**Correspondence Between
Staff and Applicant
Approval Letter**

Case Reference No: 25-DR-2017 Luxian Villas On Camelback

MEMORANDUM

Re: 25-DR-2017 2nd DRB review

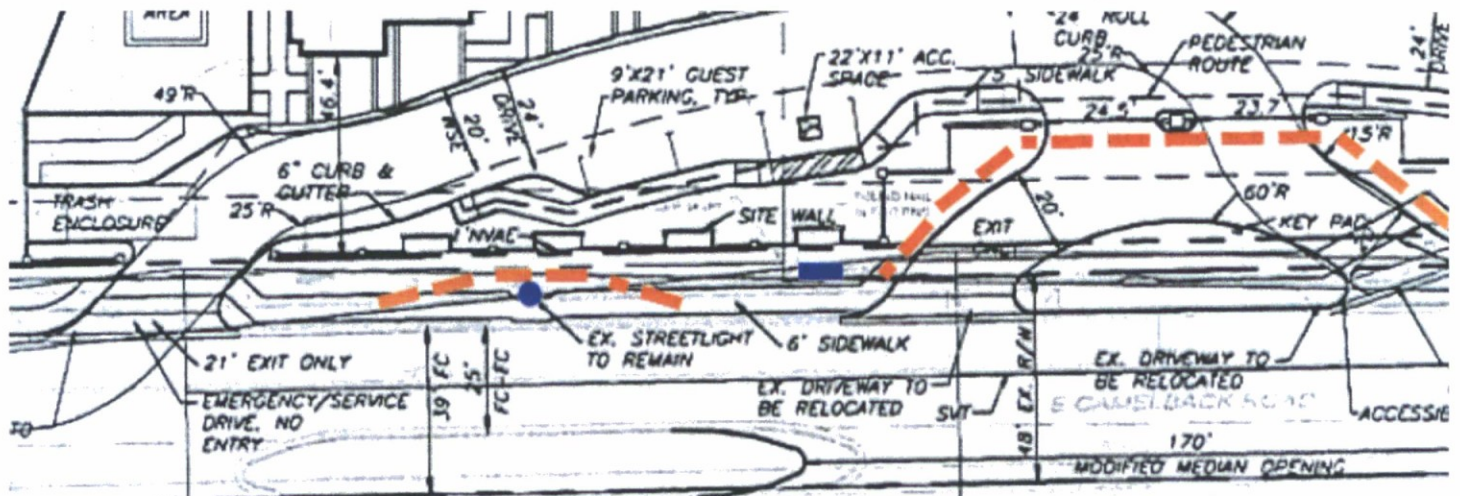
- a. **MEDIAN.** Reconstruct the existing median(s) on Camelback Road by pulling back the existing eastbound median nose near the main site driveway, in order to provide left-turn transition room into the site, and relocate any existing landscaping that will be displaced, as determined by city staff.

The zoning case site plan showed this:
